313 North Maple Drive

STAFF REPORT
CITY OF BEVERLY HILLS

**For the Design Review Commission
Meeting of July 1, 2010**

SUBJECT: A request for an R-1 Design Review Permit to allow a new two-story single-family residence located in the Central Area of the City, south of Santa Monica Boulevard at **313 North Maple Drive. (PL 101 2186)**

Proposed Rendering

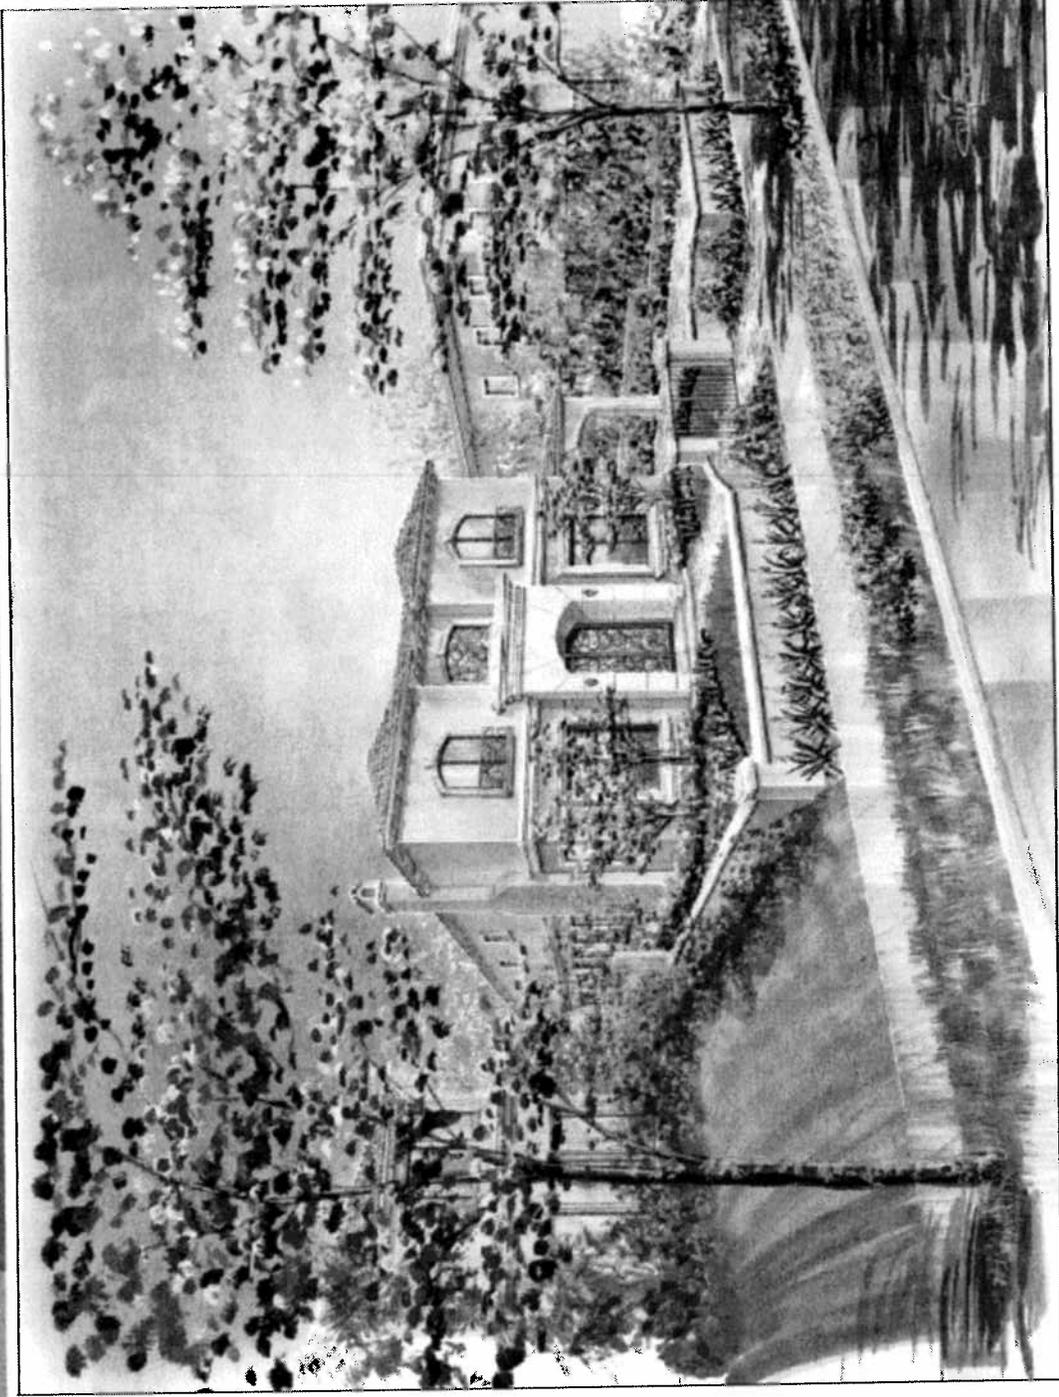
Staff has concerns with the scale and proportions of the façade design and its overall “boxy” appearance. The Commission may wish to discuss how these features can be refined.

Based on the foregoing analysis and pending the information and conclusions that may result from testimony received at the public hearing, as well as Design Review Commission deliberations, staff recommends that the Design Review Commission send the project back for restudy with direction to soften the boxy appearance and simplify the elaborate details of the design.
